**Re: EB-2024-0023 Festival Hydro Inc.  
January 1, 2025 Cost of Service Rates  
Interrogatories of the Vulnerable Energy Consumers Coalition (VECC)**

<b>REQUESTOR NAME</b>	<b>VECC</b>
<b>TO:</b>	<b>Festival Hydro Inc. (“FHI”)</b>
<b>DATE:</b>	<b>July 5, 2024</b>
<b>CASE NO:</b>	<b>EB-2024-0023</b>
<b>APPLICATION NAME</b>	<b>2025 Cost of Service Rate Application</b>

**Figure 1: Yearly Meter Deployment Plan**

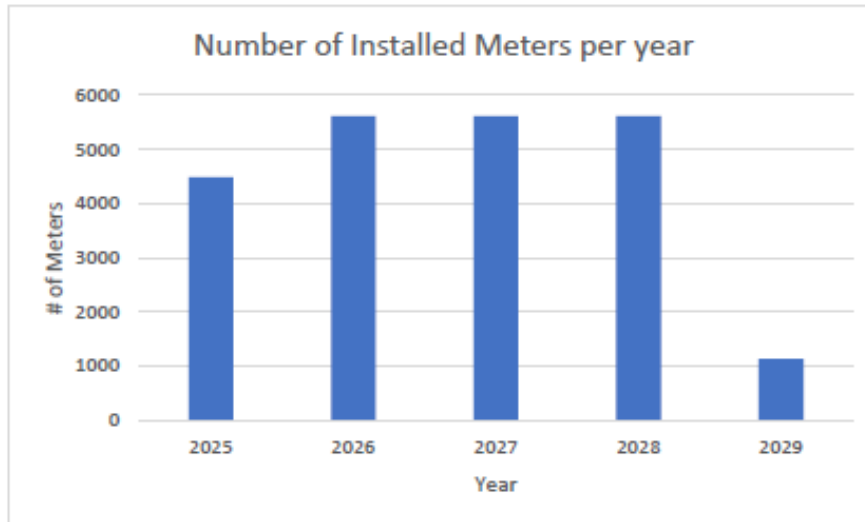
- a) Did FHI undertake an AMI review/implementation study? If yes, please provide that study.
- b) When are the results of the AMI 2.0 Pilot expected to be provided?
- c) What is the cost of the AMI pilot? How many meters are expected to be installed?
- d) Please provide the GNATT chart(s) showing the timelines and milestones for this project.
- e) What would be the cost reduction in 2025 if only half of the expected AMI 2.0 meters are installed in 2025?
- f) What is the expected life of the new AMI 2.0 meters?
